## FOUNDATION INVESTIGATION REPORT

Proposed Structures at the Crossing  
Of the Scotch River (East Branch)  
And Proposed Hwy. #417  
(Eastbound and Westbound lanes)  
Kenyon Township -- Glengarry County  
District No. 9 (Ottawa)  
W.J. 70-11028 -- W.P. 36-66-09

FOUNDATION INVESTIGATION REPORT  
For  
Proposed Structures at the Crossing  
Of the Scotch River (East Branch)  
And Proposed Hwy. #417  
(Eastbound and Westbound Lanes)  
Kenyon Township -- Glengarry County  
District No. 9 (Ottawa)  
W.J. 70-11028    --    W.P. 35-66-09

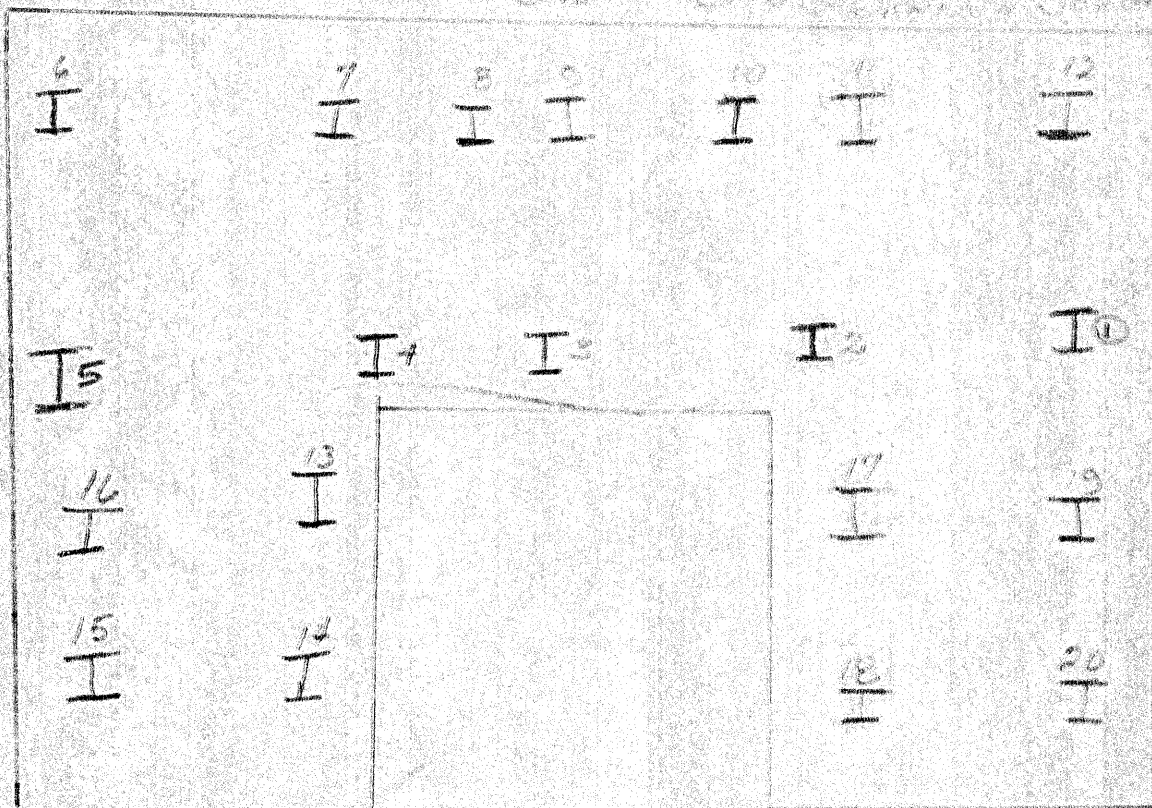
*Piles should be driven to ~~refined~~  
~~to~~ bedrock. Design load 70T  
per pile (D. 6865-1)*

*note: "to bedrock" should be added.*

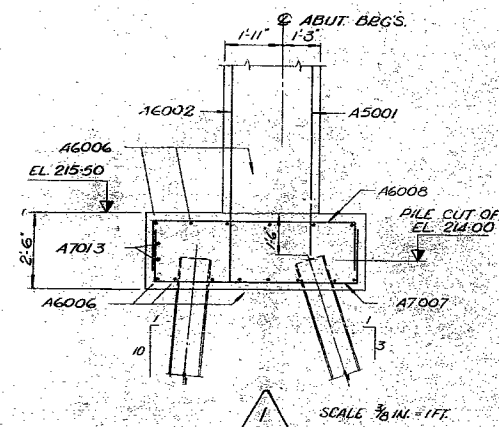
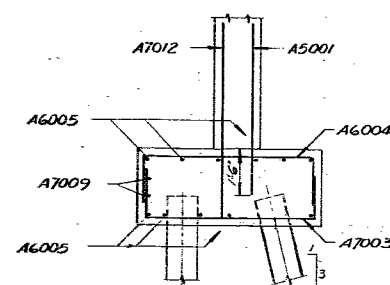
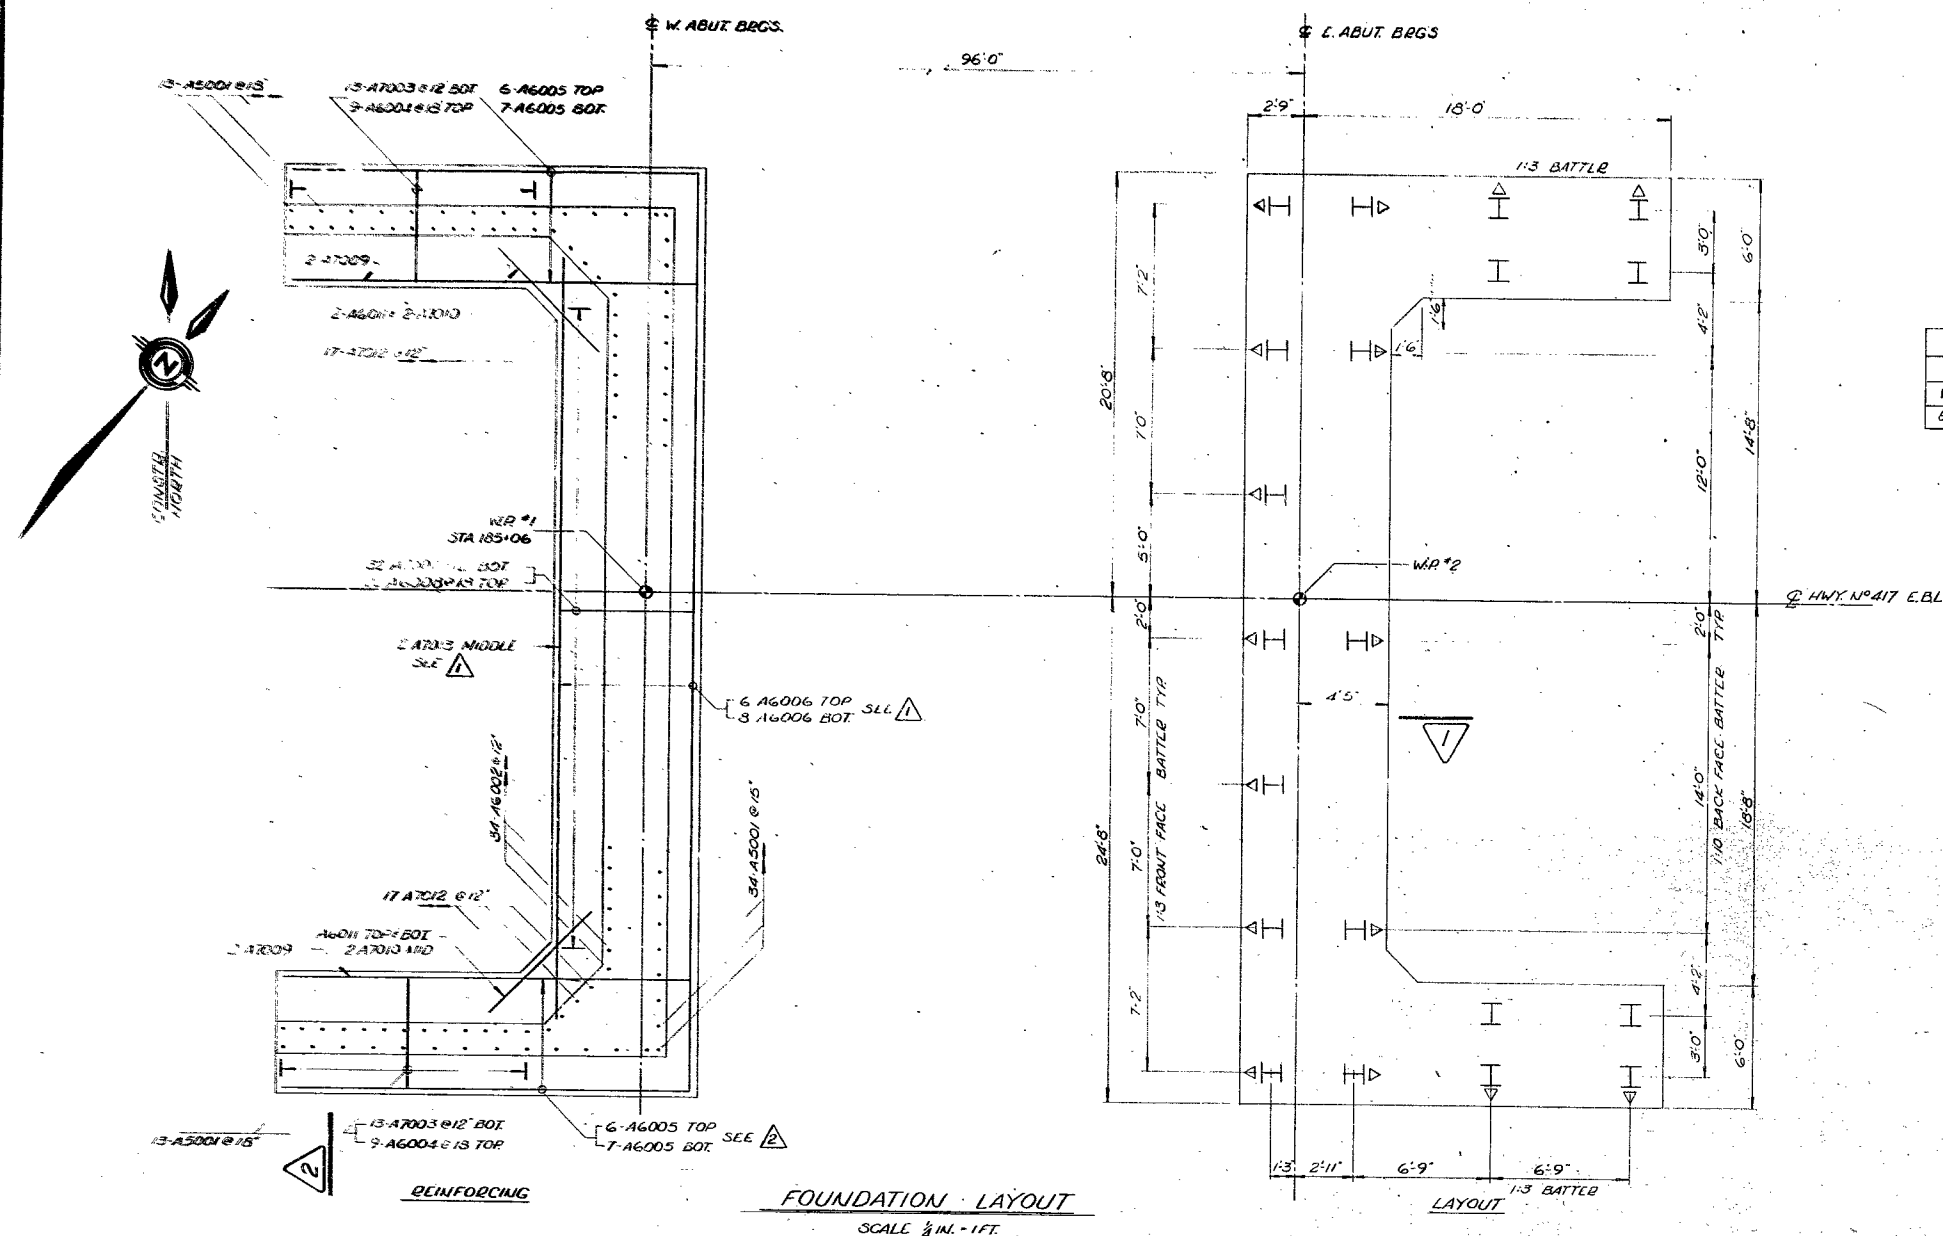
2) note on Drawing with regard to piling should  
be changed to read.
